Southern Nuclear Operating Company
Vogtle Electric Generating Plant Units 3 and 4
Response to Requests for Additional Information related to
Preservice Inspection Requirements for Steam Generator Nozzle to
Reactor Coolant Pump Casing Welds (VEGP 3&4-PSI-ALT-05)

**Response to NRC Staff Request for Additional Information (RAI) Regarding
VEGP 3&4-PSI-ALT-05**

**NRC RAI Response Regarding Inspection of *AP1000* Vogtle Units 3 & 4
and V. C. Summer Units 2 & 3 Steam Generator to Reactor Coolant
Pump Suction Nozzle Weld**

Figure 1: Illustration of SG to RCP Suction Nozzle DM Weld Outside Diameter Axial Flaw

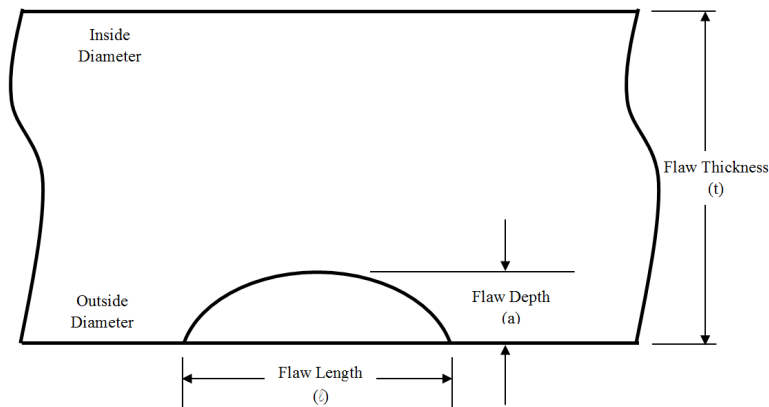
To resolve this issue, the staff requests that the licensee provide additional information or analyses to justify why the proposed examinations are an acceptable alternative to examining the full weld volume. Specifically, the staff requests that the licensee, at a minimum, provide an analysis which considers the size and nature of the largest potential defect which could be expected to be present in the outer 2/3 of the weld as well as the operating loads to which the weld will be subject for the licensed lifetime of the facility. To support the requested alternative, this analysis would be expected to demonstrate that the initiation of active degradation of the weld would not be expected to occur from the postulated defect in the outer 2/3 of the weld over the licensed lifetime of the facility.

The wall thickness, denoted as ‘t’, and the flaw depth and flaw length, denoted as ‘a’ and ‘ℓ’ respectively, are shown in Figure 1 for an axial flaw on the outside diameter of the SG to RCP suction nozzle DM weld. A circumferential flaw on the outside diameter has the same denotation for thickness and flaw configuration variables.
